**APPENDIX C9**  
**COMMENTS AND RESPONSES REPORT**

**WIND GARDEN WIND FARM, EASTERN CAPE PROVINCE  
(DFFE Reference No.: 14/12/16/3/3/1/2314)**

**COMMENTS AND RESPONSES REPORT**

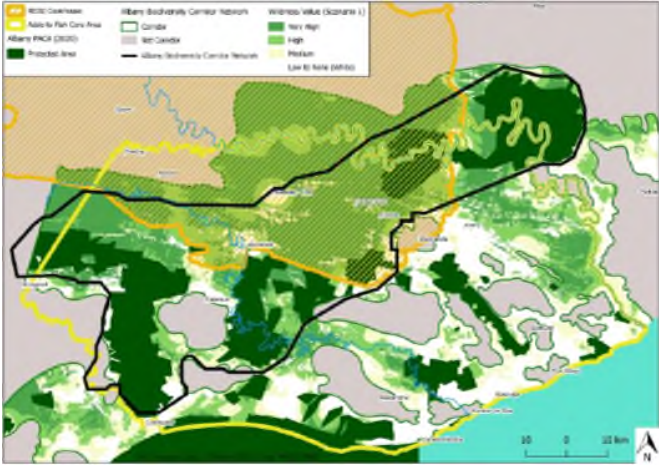
<p>3. We also remain of the opinion the proposed nest buffers are inadequate. While it may be acceptable to amend the recommended precautionary buffer widths if rigorous data collected for a particular site indicates it is appropriate, as</p>		<p>In relation to the design of the site buffers, the analysis used to inform the 2.5km distance for Martial Eagle, for example, is set out in Appendix 2. Figure 1 from that appendix is reproduced here as it illustrates the evidence base for the use of that</p>

No.	Comment	Raised by	Response
			<p>The species-specific guidelines for the Verreaux's Eagle states the following in terms of buffers:  <i>"A buffer of 3 km is recommended around all nests (including alternate nests). This is intended to reduce the risk of collisions and disturbance. This is a precautionary buffer and may be reduced (or increased) based on the results of rigorous avifaunal surveys, but nest buffers should never be less than 1.5km."</i> The buffers recommended by the specialist for this species are in line with these.</p>

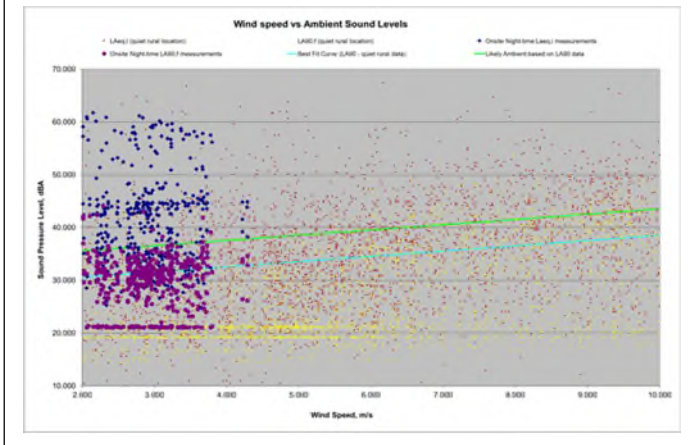
<p>107. Based on inadequacy of the studies there is no data regarding how far and at what intensity the sound in this frequency range will travel. This is a material omission. The impact this could have on the terrestrial mammals and megafauna in particular is unassessed unresolved.</p>		<p>The noise specialist has advised that while there are studies that highlight that Low-Frequency Noise and Infrasound may be detected up to large distances, it should be noted there is a big difference between detection and audible. There is a vast difference between a research paper and a noise study. This is illustrated below with an extract of such a study that indicate that Low-Frequency Noise and Infrasound can be detected over significant distances (Wind turbine low frequency and infrasound propagation and sound pressure level calculations at dwellings, The Journal of the Acoustical Society of America 144, 981 (2018); <a href="https://doi.org/10.1121/1.5051331">https://doi.org/10.1121/1.5051331</a>).</p>

No.	Comment	Raised by	Response
			<p>The specialist has noted that the article referenced is a self-published article and not a peer-reviewed paper and therefore does not have any scientific standing unless accepted and published in an internationally recognised journal or similar publication.</p> <p>SPLs were obtained at four distances, 125, 2.5, 5, and 10 km from the wind turbines using Chaparral Physics model-25 microbarometers (Chapparal Physics, Fairbanks, AK). At the 125 m distance the microbarometer sensors were within 2 m of the transducers used to measure wind turbine sound power (Sec. II G). For isolation from wind noise the microbarometer was mounted inside a 0.5 m diameter × 0.9 m high polyvinyl chloride plenum attached to four 15 m long, 1.9 cm outside diameter garden soaker hoses, which extended radially in 4 directions to form an orthogonal “X” shape. Data were recorded using a Nanometrics Trident 24 bit digitizer (Nanometrics, Ottawa, Canada) with a 200 Hz sample rate.</p> <p>One should note the specialised equipment used, with the barometers mounted within a plenum, isolated from the typical environmental noise associated with increased wind speeds, connected with 15 m long hoses, that would act like resonators to “amplify” certain frequencies of interest. With these specialized equipment, methodologies and statistical analysis the harmonics, associated with the wind turbines, were detected as illustrated below:</p>

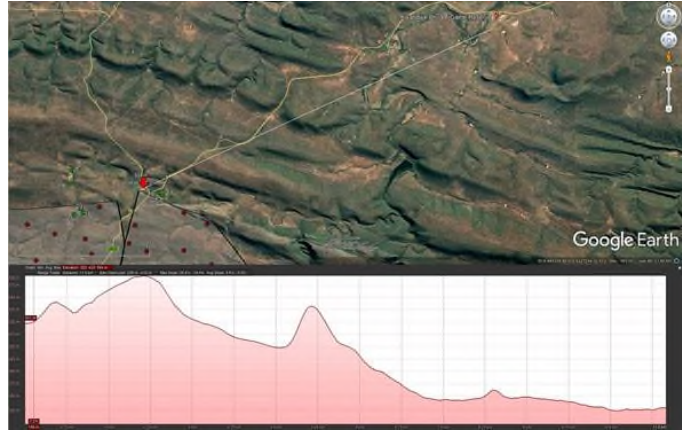
No.	Comment	Raised by	Response
			 <p>However, what one should realise is that, apart from the measurements at 125 m, that the levels detected at 2.5, 5 and 10 km distances are very low. In practice these frequencies will be undetectable as environmental noises, induced by the high wind speeds, will completely mask these signatures. Please note the typical spectral frequencies measured in the Addo Elephant park by the noise specialist, indicating the typical high Infrasound and Low-frequency Noise present in the environment with higher wind speeds:</p>

No.	Comment	Raised by	Response
			 <p>The graph, titled "Spectral Frequency Distribution at different wind speeds", plots Sound Pressure Level (dB) on the y-axis (ranging from 0 to 90) against Frequency (Hz) on the x-axis (logarithmic scale from 100 to 10000). Multiple colored lines represent different wind speeds, showing a general downward trend in sound pressure level as frequency increases, with a slight plateau or change in slope between 1000 Hz and 10000 Hz.</p> <p>This is highlighted in the findings of a study on Infrasound levels near windfarms, done by the Environmental Protection Authority of South Australia in February 2013 (study available at <a href="https://www.epa.sa.gov.au/files/477912_infrasound.pdf">https://www.epa.sa.gov.au/files/477912_infrasound.pdf</a>). This study measured infrasound levels at urban locations, rural locations with wind turbines close by, and rural locations with no wind turbines in the vicinity. It found that infrasound levels near wind farms are comparable to levels away from wind farms in both urban and rural locations. Infrasound levels were also measured during organized shut-downs of the wind farms; the results showed that there was no noticeable difference in infrasound levels whether the turbines were active or inactive.</p> <p>Therefore, considering the practical distances that sound (including Infrasound and Low Frequency Noise) travel, the significant acoustic energy being present at low frequencies due to wind-induced noises as well as the findings of available studies, it must be concluded that Infrasound and Low Frequency Noise is of a low concern further than a few</p>

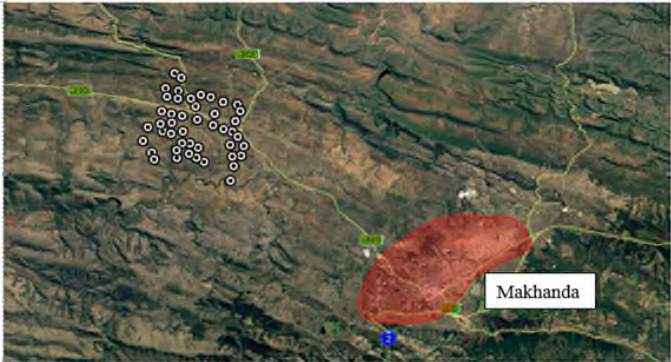
No.	Comment	Raised by	Response
			<p>published describing that model does not include sufficient detail to be able to replicate it without further information on the model parameters.</p> <p>What is clear, however, is that even adopting very wide buffers, the collision risk to eagles is not removed and that a residual collision risk will remain. That will remain the case however much modelling and analysis is carried out, as both Murgatroyd et al's work and the specialist's local studies have shown that these birds range widely from their nests. Avoiding the close proximity to nests can reduce the risk, but not remove it altogether.</p>
	<p>7. The proposed buffers for Martial Eagle nests are also significantly less than recommended in most other impact assessments (i.e. 5-6 km). Van Eeden et al. (2017) 's research tracking Martial Eagles in the Kruger indicated a 50% Kernel Density with an average of 16.5km<sup>2</sup> - which would suggest a buffer with a radius of 2.9 km from a nest would be necessary to avoid just the core territory. Martial Eagle territories are likely to be much larger in the area of the proposed development.</p>		<p>This follows on from the same principle as above, where Murgatroyd et al highlighted the limited benefit of simple circular buffers and their inefficiency in defining areas of higher collision risk, as these eagles do not randomly move around a specific distance from their nests but choose to forage and fly over specific areas and habitats within their range. The spatial modelling undertaken by the specialist has shown the importance of distance from the nest, but also altitude (higher flight activity in the 600-800m range), distance from ridge lines (higher closer to ridge lines), and slope (higher in areas of steeper slope).</p> <p>In relation to the design of the site buffers, the analysis used to inform the 2.5km distance for Martial Eagle is set out in Appendix 2 of the AIA (Appendix E of the BAR). Figure 1 from that appendix is reproduced here as it illustrates the evidence base for the use of that specific distance. The survey data showed a strong relationship between flight density and distance from the nest, but this relationship flattened out beyond 2.5km. The highest densities were</p>

No.	Comment	Raised by	Response																																																		
			<p>recorded within 500m of nests and there was a steady decline in flight density with distance from the nest, but only up to a distance of 2.5km. Beyond 2.5km flight density was consistently lower. A ny exclusion of turbines beyond 2.5km would be of much less benefit in reducing collision risk. A similar result was found for the Choje East Block, though there, higher flight activity was noted within 1.5km of the nest (though with a smaller amount of baseline data available a precautionary approach was adopted and a 2.5km applied in the East and as well as the West).</p> <p><i>Appendix 2. Figure 1. Martial Eagle flight density and distance from the nest, Choje West June 2019 - August 2020 (mean ± 95% confidence limits).</i></p>

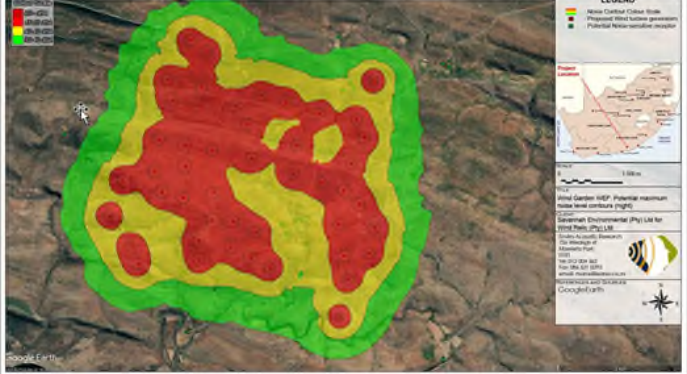
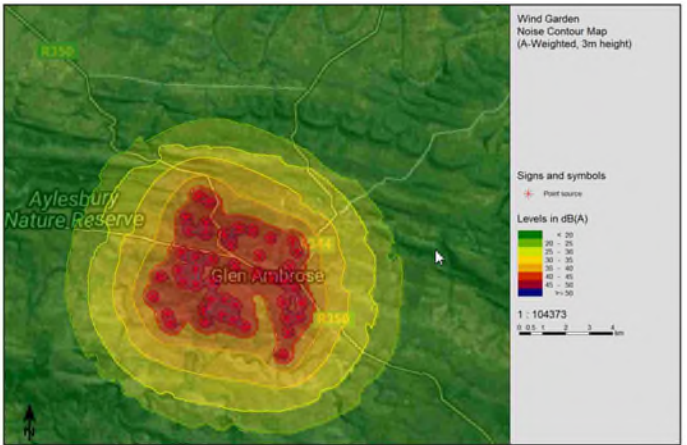
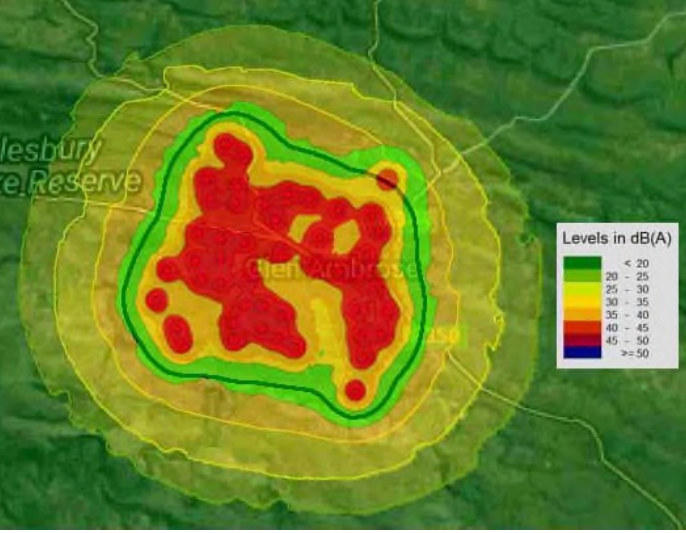
<p>2.4.3. At none of the eight noise sensitive locations within the proposed WEF area were ambient sound levels measured, see below:</p> 		<p>There are a number of factors that determine the suitability of a measurement location when deploying sound level measurement equipment (SLMs), including; k. Access and permission to deploy the SLMs; l. Potential safety and security concerns; m. Type of trees and faunal activity in the vicinity of the proposed measurement location. E.g. no instruments are deployed at properties with certain fruit trees due to constant bird communication significantly influencing the measurements; n. Presence of standing water, especially wetlands (same reason as above, with frogs being a significant noise source); o. Potential presence of dogs and baboons that may damage equipment, etc. The markers representing NSD 15, 16, 17, 18 and 20 is a number of dwellings identified using aerial images. It was however reported that only dwelling 15 is used by the owner, with</p>

No.	Comment	Raised by	Response
	<p>The report records residual / ambient noise measurements at five locations. There are however twenty three noise sensitive locations (as stated in the report) and thus for eighteen of them there is no measurement record of existing conditions.</p>		<p>dwelling 20 being used on a temporary basis during the hunting season. The owner of this property is a willing participant in the wind farm development.</p> <p>The author of the report could however not gain access initially to the farm of NSD 15 to assess the site to deploy an SLM. However, considering the proximity of the river, this measurement location was excluded in lieu of a location at NSD 11. The site visit at NSD 11 highlighted that the river had little standing water and that the closest wetland was further than 300 m (a dam was visible approximately 100 – 200 m from potential measurement locations at NSD 15/20). In addition, SANS 10103:2008 does not require the measurements of ambient sound levels (the residual noise) at each potential receptor, nor does this guideline define, set or propose locations where sound levels should be measured. Nor are the author aware of any acoustic consultant in South Africa that would measure the ambient sound levels at all identified receptors. In addition, the measurement of future ambient sound levels is normally recommended once a noise study are completed, identifying potential receptors where noise levels may be of concern. Machoy fails to highlight that more than 750 measurements were collected, including 480 measurements during the quieter periods. The findings from the noise study determined that “ambient sound levels are generally low and typical of a rural noise district during low wind conditions”. This is the lowest acceptable rating level (rating level for noise in districts as per SANS 10103:2008) and more data, or more measurement locations will not change this. In a focus area with a more complex sound character more measurement locations may be more beneficial. This</p>

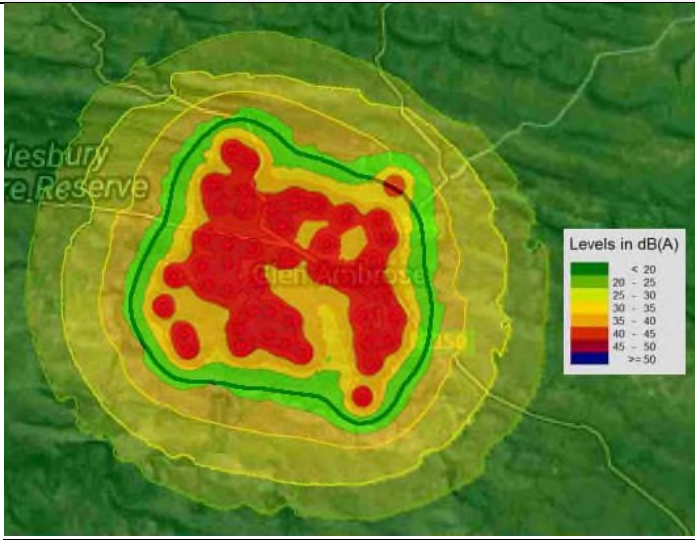
2.7.4. At none of the eight noise sensitive locations within the proposed WEF area were ambient sound levels measured.		There are a number of factors that determine the suitability of a measurement location when deploying sound level measurement equipment (SLMs), including:  a. Access and permission to deploy the SLMs; b. Potential safety and security concerns; c. Type of trees and faunal activity in the vicinity of the proposed measurement location. E.g. no instruments are deployed at properties with certain fruit trees due to constant bird communication significantly influencing the measurements;

No.	Comment	Raised by	Response
			<p>d. Presence of standing water, especially wetlands (same reason as above, with frogs being a significant noise source);</p> <p>e. Potential presence of dogs and baboons that may damage equipment, etc.</p> <p>In addition, SANS 10103:2008 does not require the measurements of ambient sound levels (the residual noise) at each potential receptor, nor does this guideline define, set or propose locations where sound levels should be measured. Nor are the author aware of any acoustic consultant in South Africa that would measure the ambient sound levels at all identified receptors.</p> <p>In a focus area with a more complex sound character more measurement locations may be more beneficial. This would be a location with a combination of significant noise sources (e.g. industry, mines, railways and roads). This project does not have these noise sources, and such, additional sound level measurement locations would not provide better information.</p>

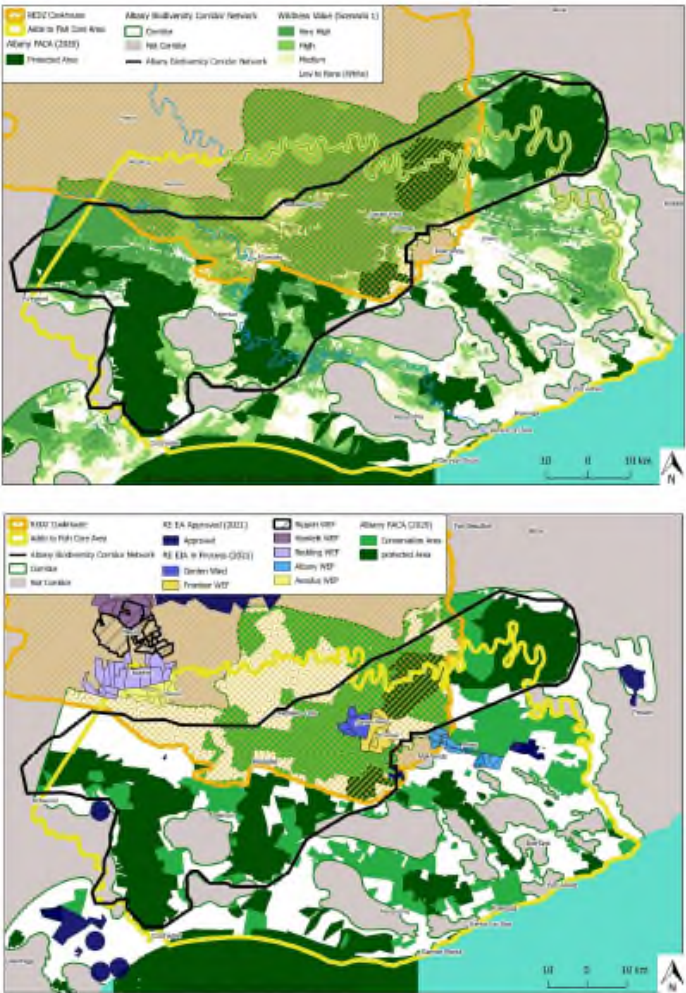
<p>47.2. The consequence is that, for example, the large impacts are camouflaged which, in turn, can result in a very large</p>		<p>As the values calculated for the impacts are presented in the report, the actual impacts are reflected together with</p>

No.	Comment	Raised by	Response																												
	<p>misrepresentation of the actual impacts. See table and graph below that illustrate the principle and show the difference between using categories versus actual impacts.</p> <p>Table 1—Calculation of changes in impact per factor category or actual impact</p>
